## **Landscape Comments on Planning Application**

**July 2022**

**Ribble Valley Borough Council Planning Application Reference: 3/2021/0661**

### **Haweswater Aqueduct Resilience Project – Marl Hill Section**

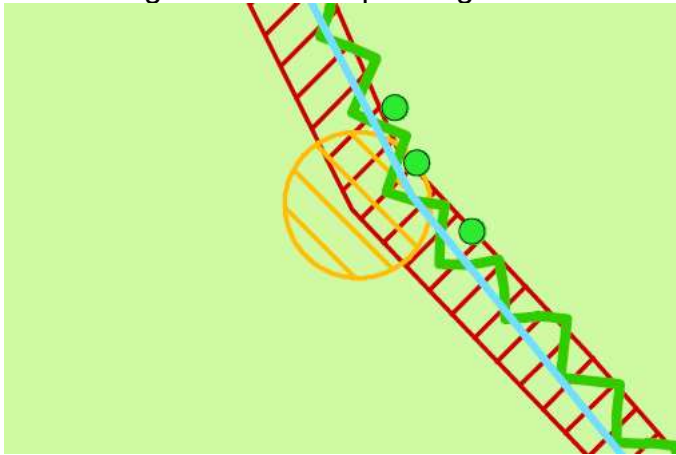
The proposals regarding existing vegetation do not differentiate between trees or shrubs. Everything is lumped together under the words, "*Existing vegetation.*" It is possible to determine what the various existing vegetation 'shapes' are with reference to the tree survey, but for ease of use, the different types of vegetation should have been clearly labelled on the environmental masterplans.

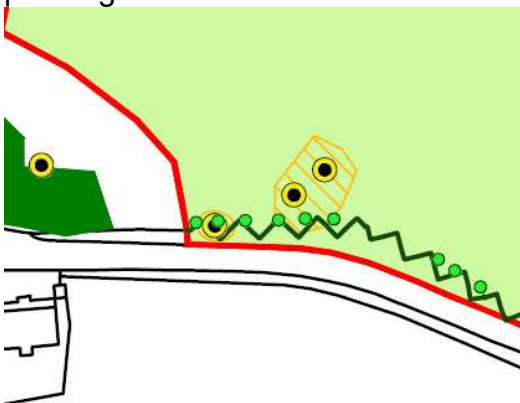
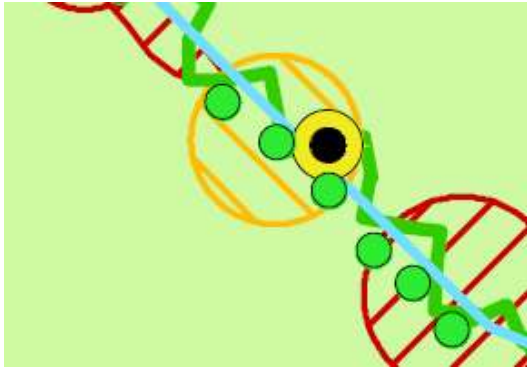
The approach to what will or might be removed is inconsistent. As can be seen in the screenshot below from page 2 of 4, one plant (a tree?) is shown at risk of removal even though it lies within planting which would be removed.

At the location in the screenshot below, the vegetation adjacent to the hedgerow is identified as being at risk even though the hedgerow itself is down to be retained. As the two are so close together I cannot understand why only some of the vegetation is at risk of removal. Their location on the edge of the compound site also suggests that removal is unnecessary. Removal of the vegetation would likely have adverse impacts on the retained hedgerow – root compaction, root loss, etc. New tree planting is also shown within the root protection areas of the existing hedgerow.

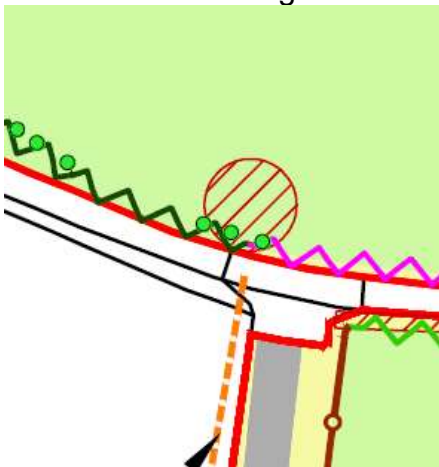
At various locations – see an example in the screenshot below – the applicant proposes to plant trees within the root protection areas of existing vegetation (which is presumably trees, shrubs and hedgerows - the drawings do not clearly mark the different types). Generally, it is advisable to avoid undertaking any works within root protection areas especially if they involve excavation.

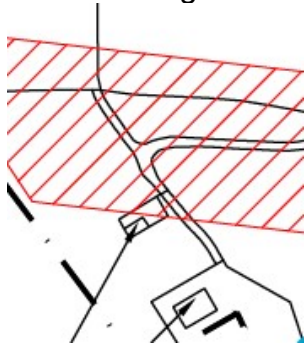
No details of the surfacing materials to be used for the access tracks have been provided. I recommend locally sourced stone oversewn with grasses (seed mix to be agreed with the county council ecologist) to minimise the visual effects of what would be temporary scars across the landscape.
